**TOWN OF HERNDON, VIRGINIA
PLANNING COMMISSION PUBLIC HEARING AGENDA
JANUARY 28, 2019
HERNDON COUNCIL CHAMBERS BUILDING
765 LYNN STREET
7:00 P.M.**

Subject: Development Plan #17-01, 555 Herndon Parkway

Title: DEVELOPMENT PLAN - DP #17-01, 555 Herndon Parkway.

PROJECT NO: 15002.001.00
SCALE: 1"=30'
DATE: 08-08-2018
DESIGN: JR,WR
DRAWN: WR
CHECKED:
SHEET No.
5.0 OF 22.0

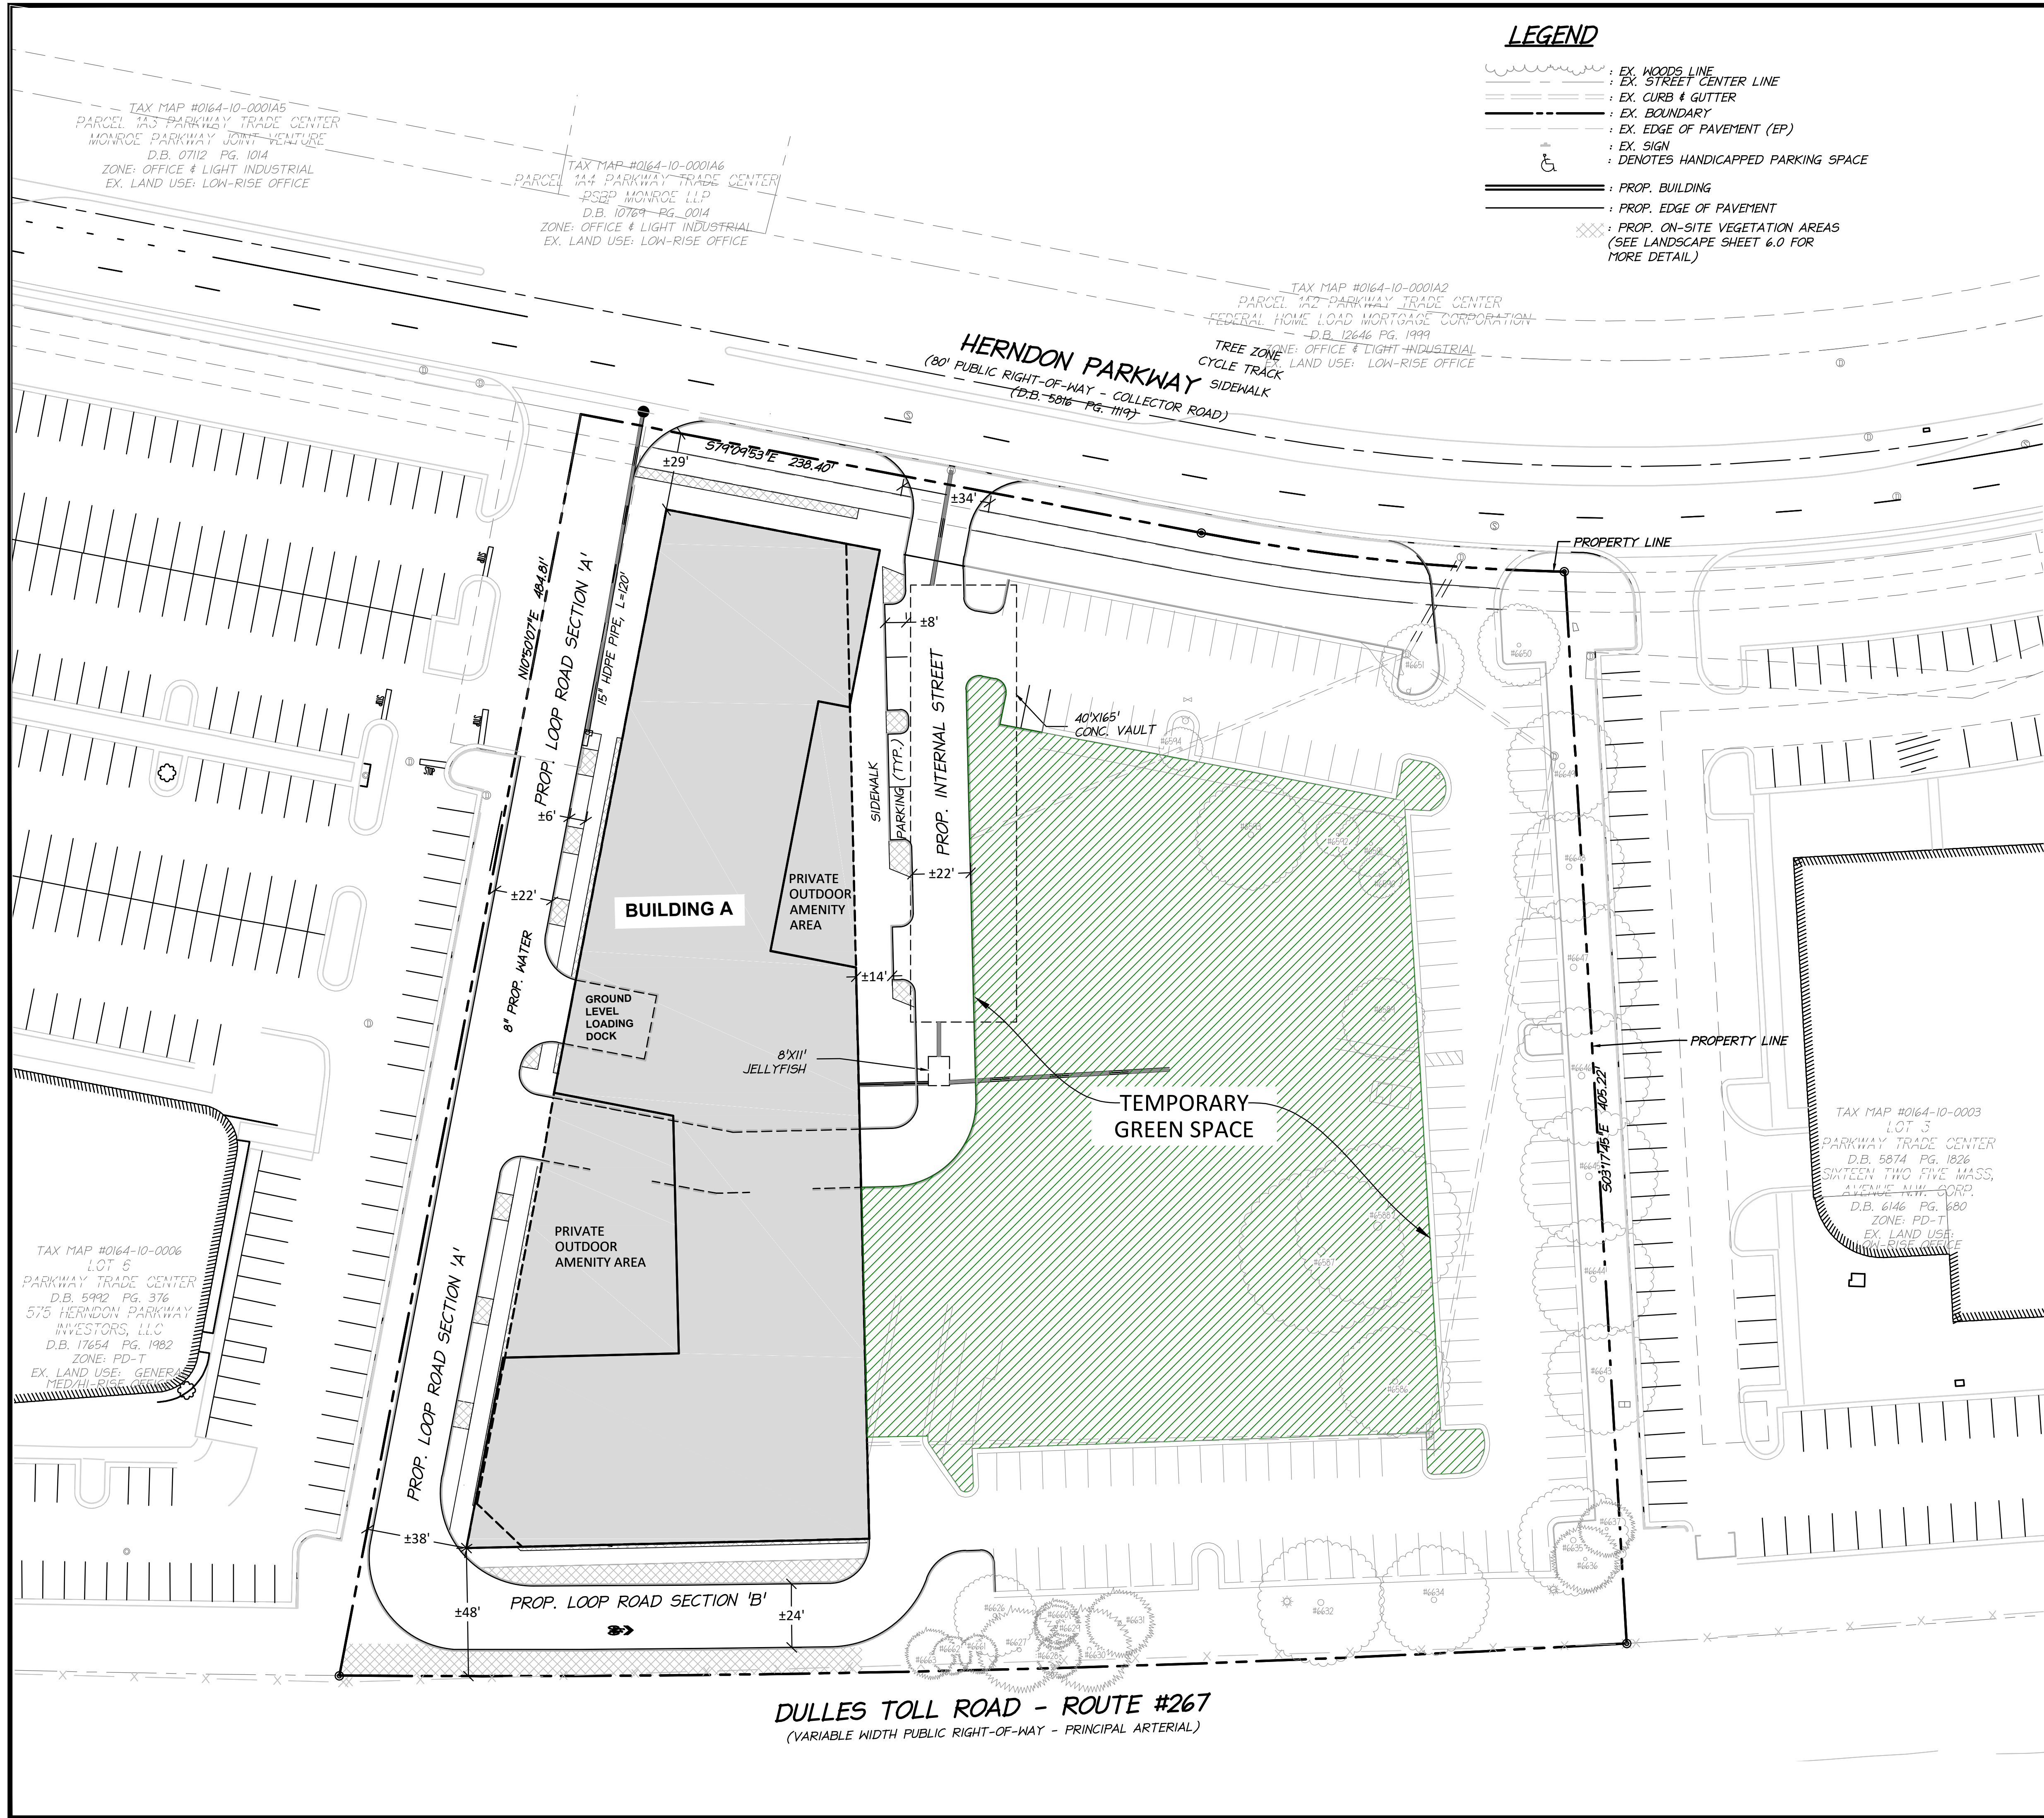
8. Sheets 5.1 to 5.3 of the development plan show the three phases and the proposed interim conditions of the areas not included in each phase. More information is necessary to evaluate the phasing plan. Additional sheets should be provided that show the interim plan conditions if Buildings A and C are built only, if Buildings A and B are built only, and if Buildings B and C are built only. Information and a visual exhibit for inclusion in the plan set should also be provided that explains and shows how the interim podium/garage walls in the areas that would connect with the abutting Phase will be finished. The design guidelines state that exposed garage walls during an interim phase should be screened or articulated with an architectural treatment.

PROJECT NO: 15002.001.00
SCALE: 1"=30'
DATE: 08-08-2018
DESIGN: JR, WR
DRAWN: WR
CHECKED:
SHEET No.
5.2 OF **22.0**

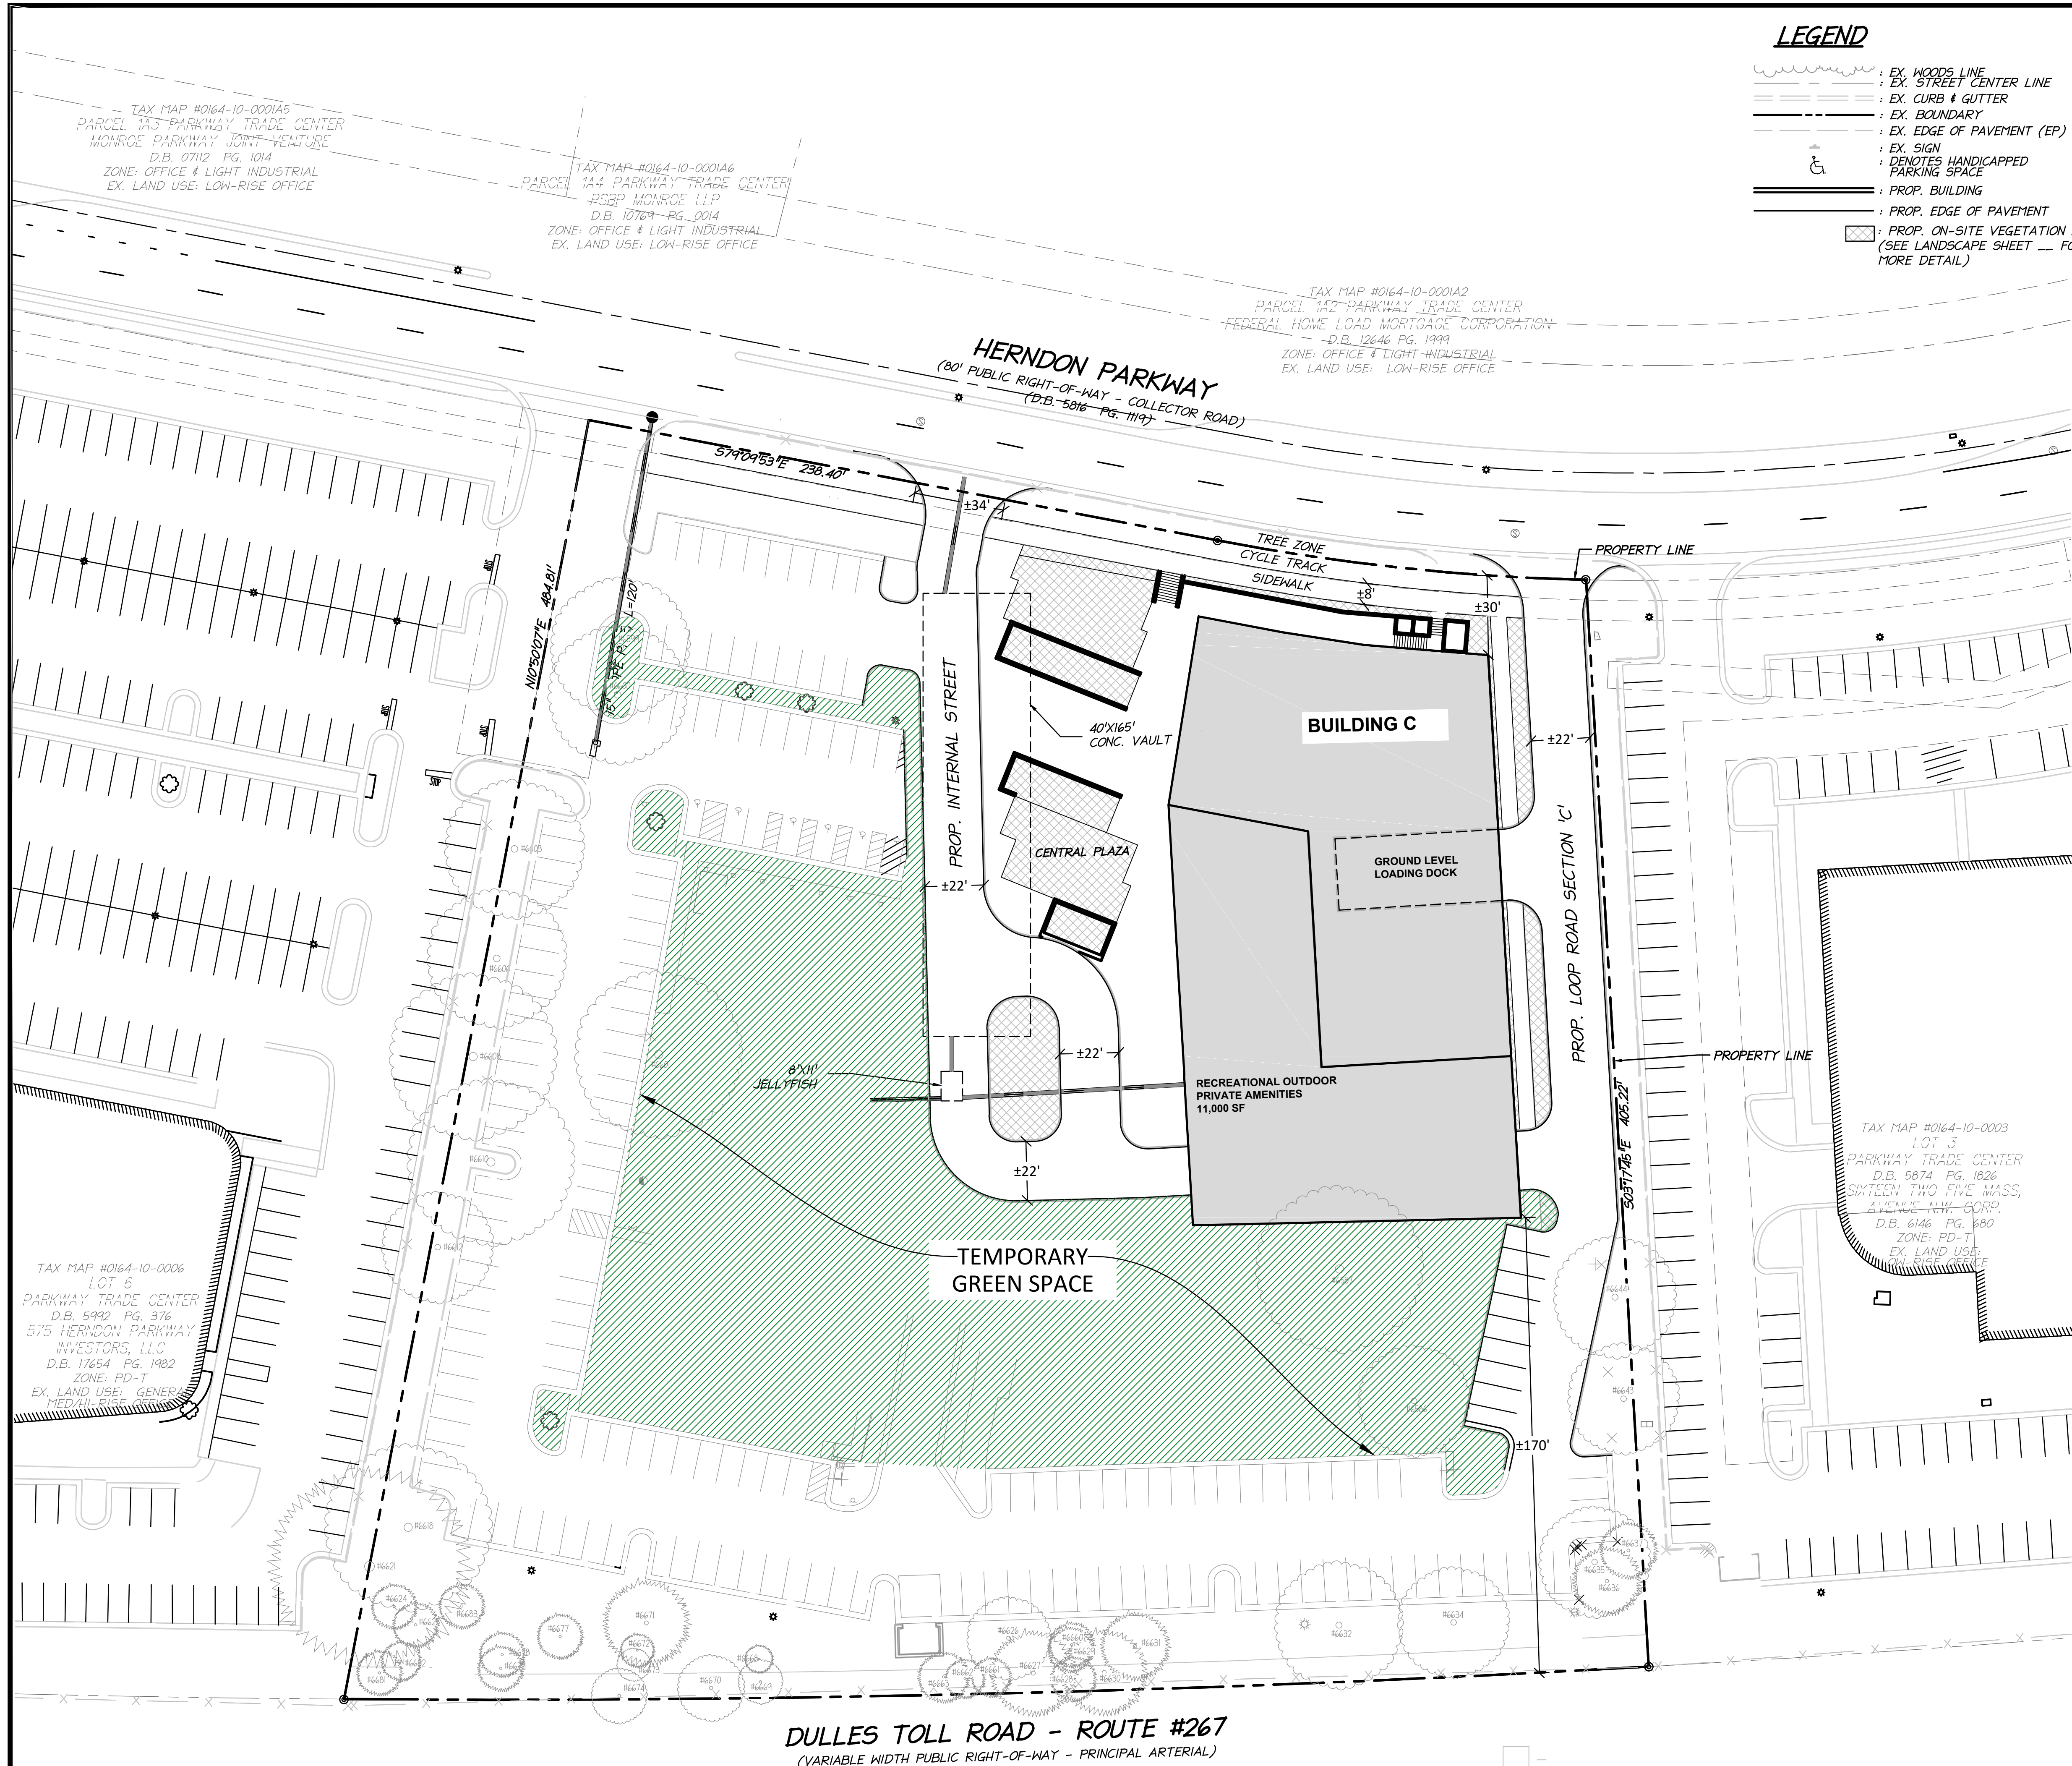
13. The phasing plans indicate that much of the existing surface parking lots would remain on-site as interim conditions. Clarification should be made as to the purpose and need of those lots since each building is parked with the integrated structured parking garage.
